**TOWN OF NEWBURGH
PLANNING BOARD
TECHNICAL REVIEW COMMENTS**

PROJECT: CBPS REALTY, LLC SELF STORAGE
PROJECT NO.: 2018-20
PROJECT LOCATION: SECTION 35, BLOCK 1, LOT 21.2
REVIEW DATE: 24 JULY 2019
MEETING DATE: 1 AUGUST 2019
PROJECT REPRESENTATIVE: FUSCO ENGINEERING

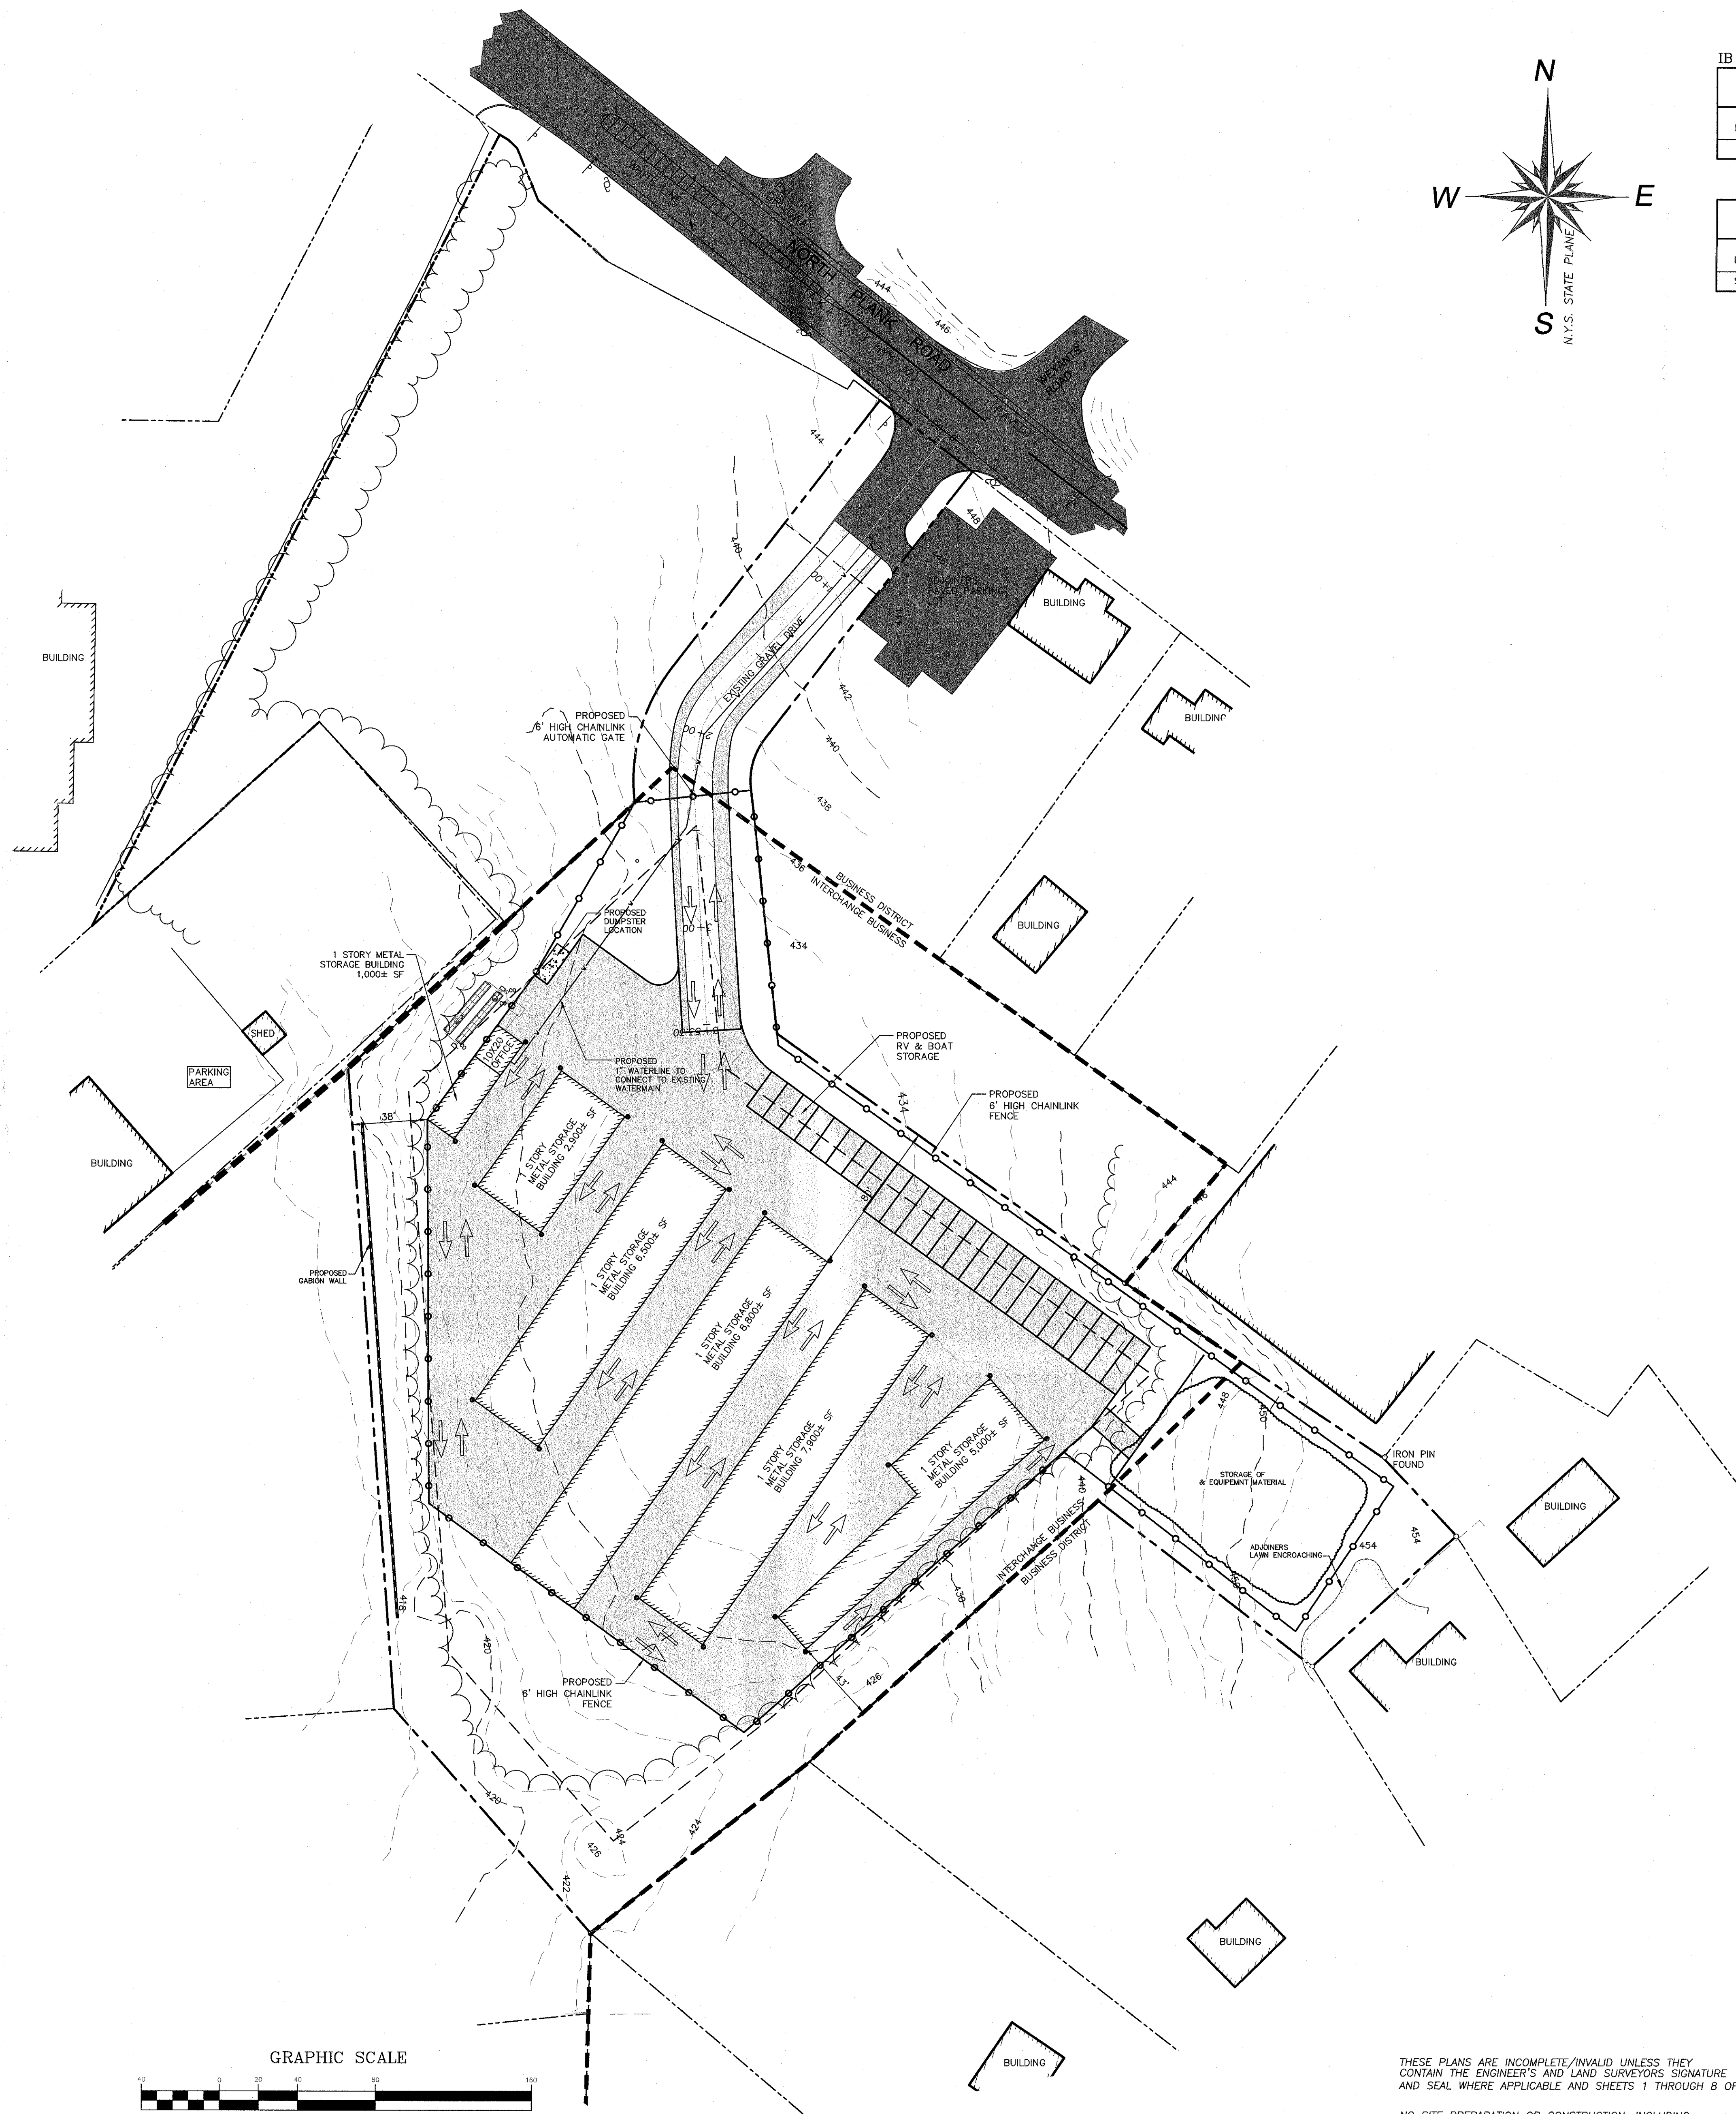
1. Numerous drawings are labeled as existing condition and proposed erosion control. Drawing titles should be revised accordingly.
2. The outlet control structure PDA-1 identifies and 18-inch diameter outlet pipe while the plans identify a 24-inch diameter outlet pipe.

STREET SHADE TREE
(DECIDUOUS)
N.T.S.

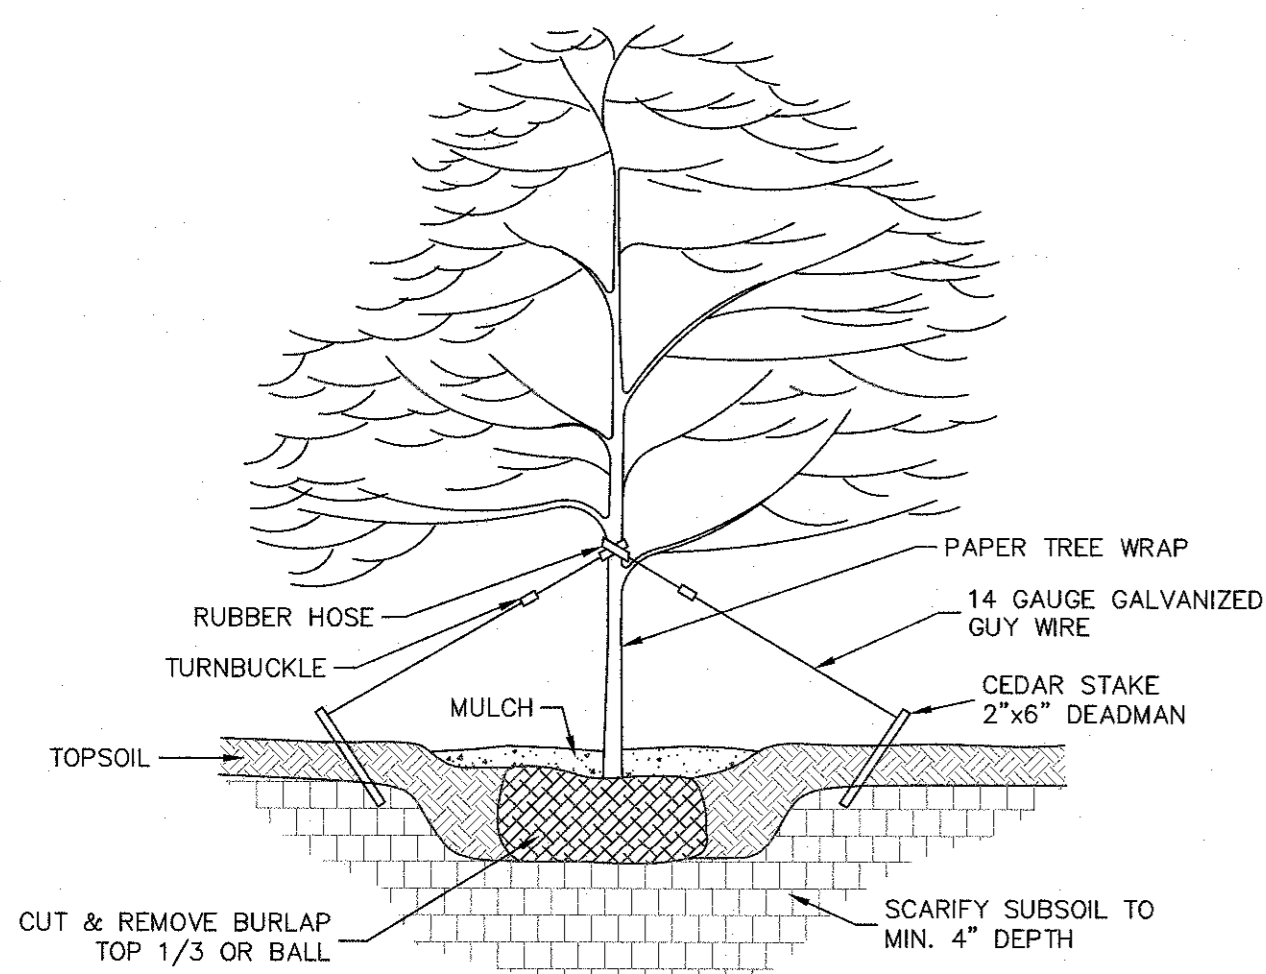
13. Karen Arrent's comments regarding the landscape plans should be received. It is noted that the plan consists of 39 Arborvitae while the detail identifies a deciduous shade tree.

RIP-RAP OUTLET PROTECTION DETAIL
N.T.S.

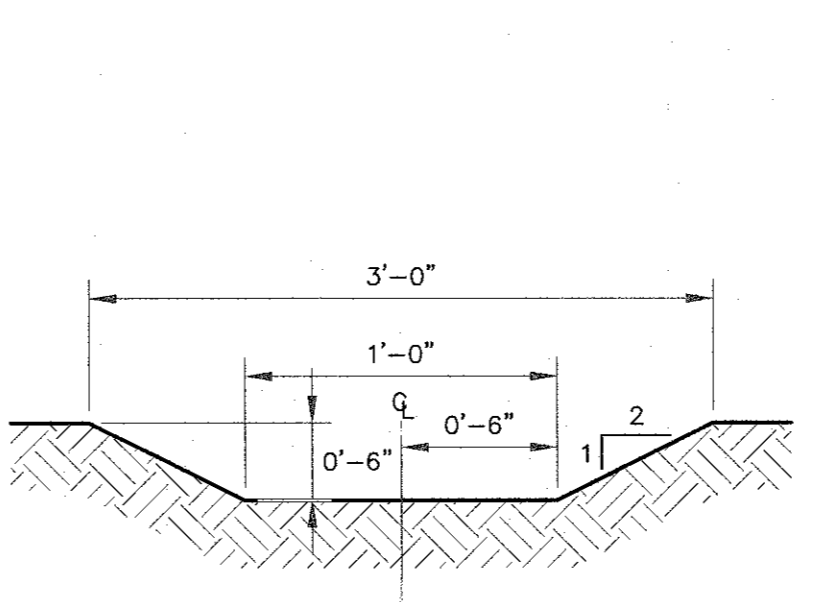
3. Response letter identifies that the riprap outlet to the detention pond has been revised to depict it on the property however, the riprap still extends past the property line.

OUTLET CONTROL STRUCTURE PDA-1
N.T.S.

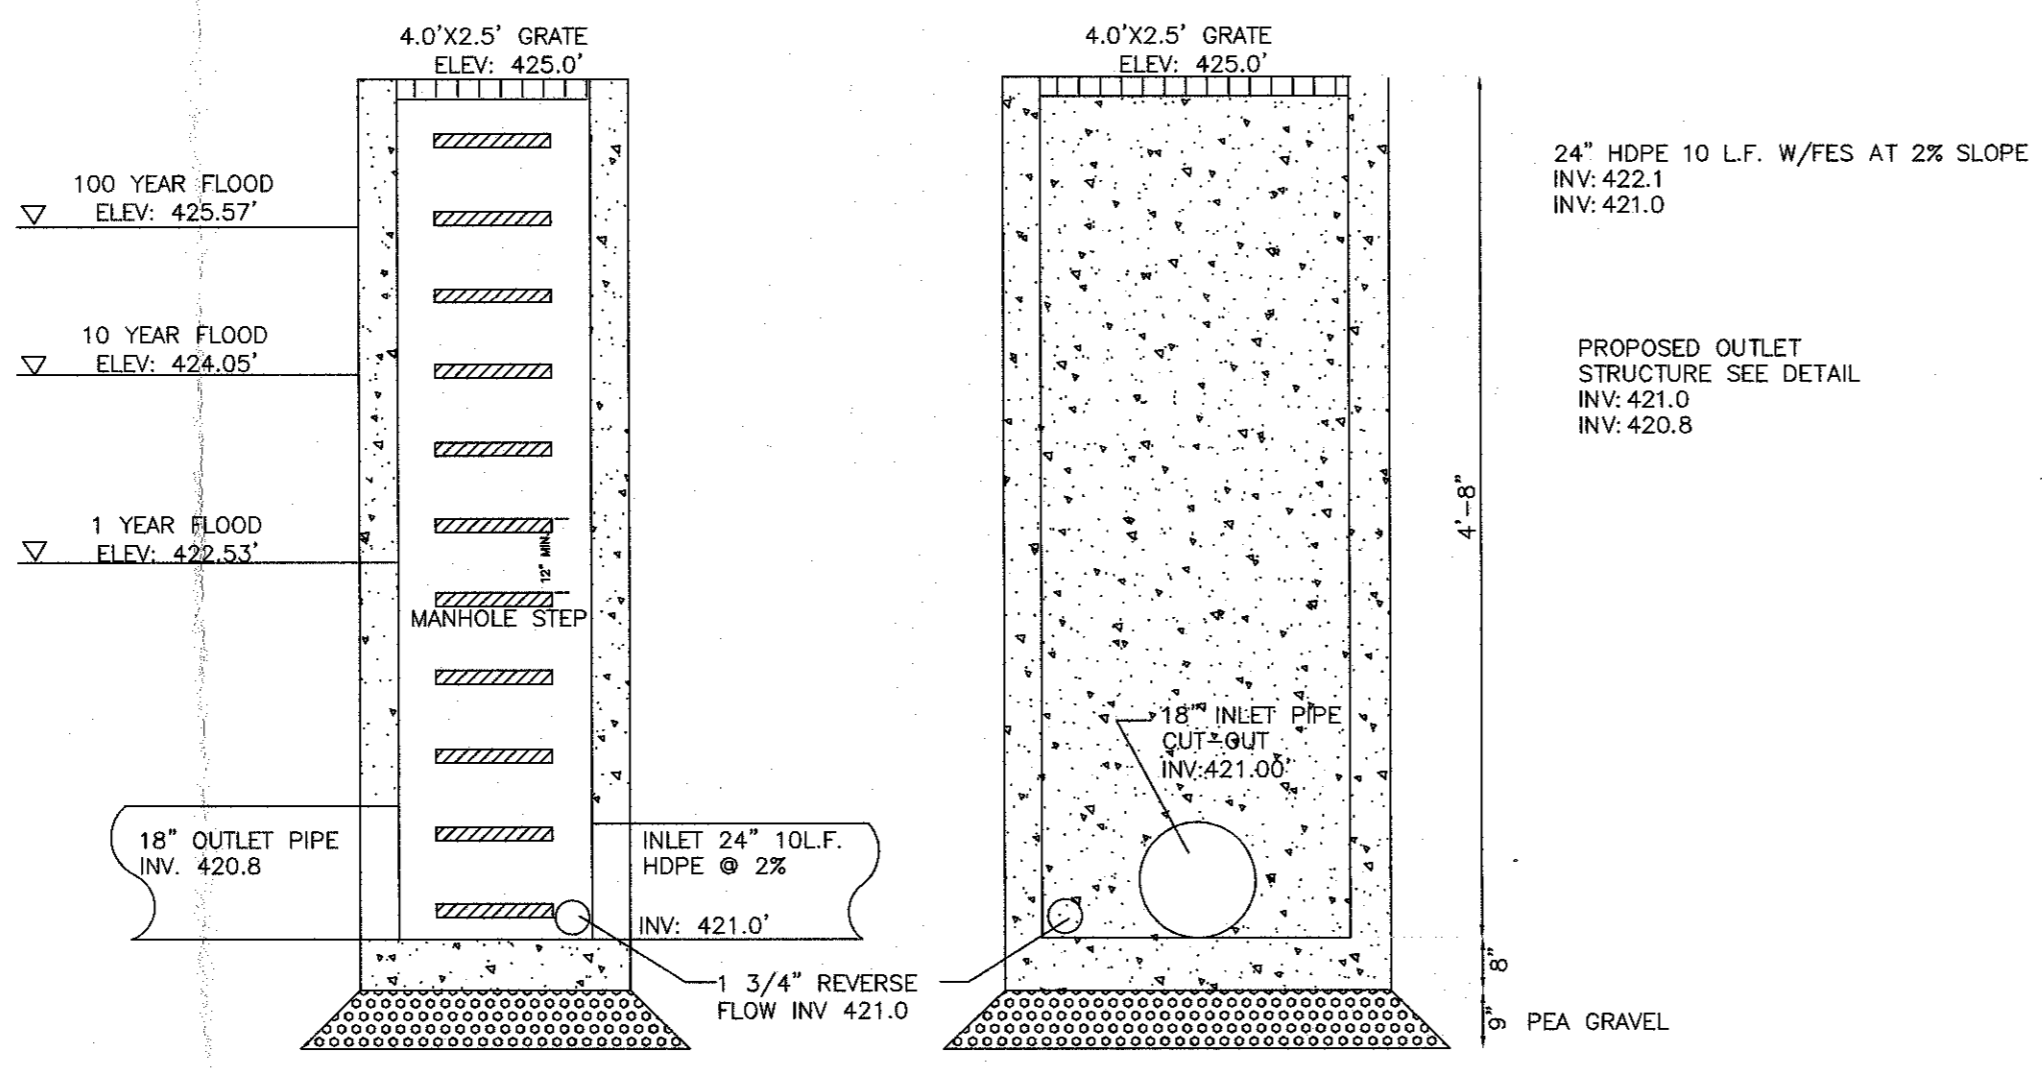
4. Slope of the 24-inch HDPE 10 lineal ft. outlet pipe from detention pond to outlet control structure is identified at 2%. Inverts are identified as 422.1 and 421.0. Check slopes or inverts which appear to be incorrect.

SEWAGE DISPOSAL DESIGN CRITERIA

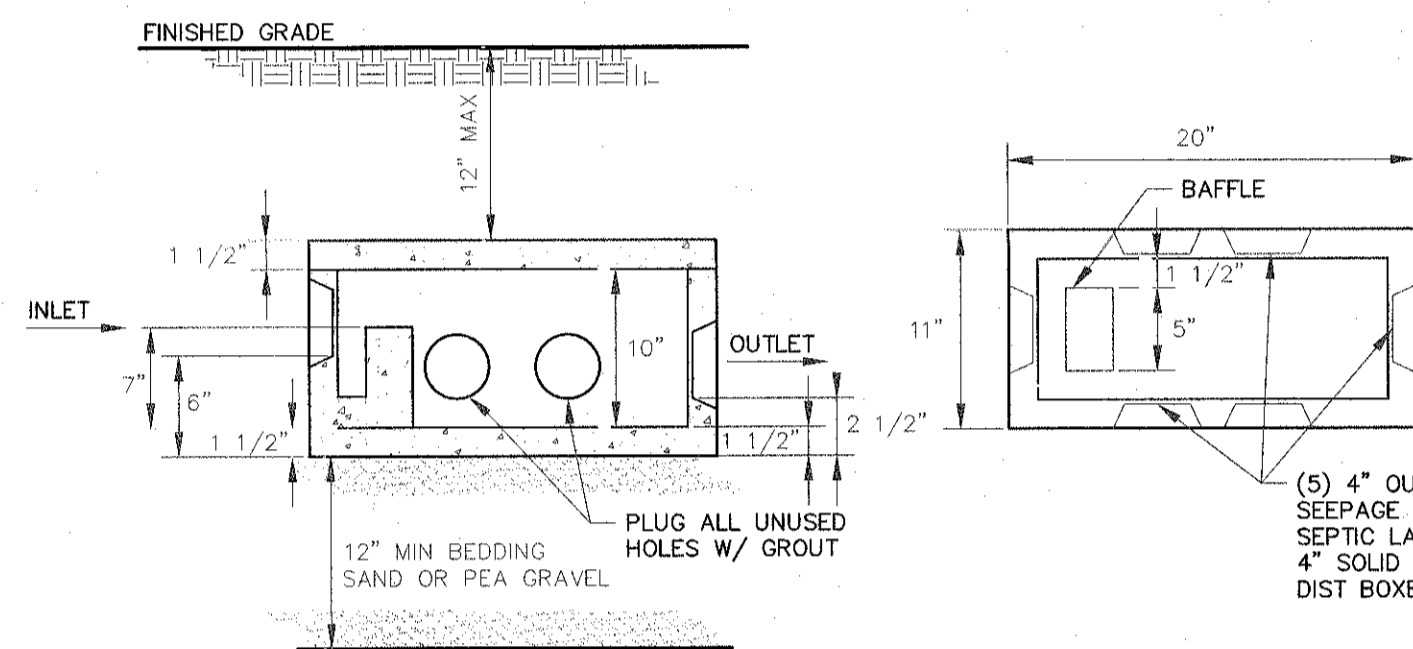
8. Sheet 8 of the plan set identifies septic system details. Actual system design components should be provided including deep tests, percolation tests, and design flow rates. The sewage disposal design criteria chart identifies design for a 4-bedroom house with 5 lines at 60 lineal feet.
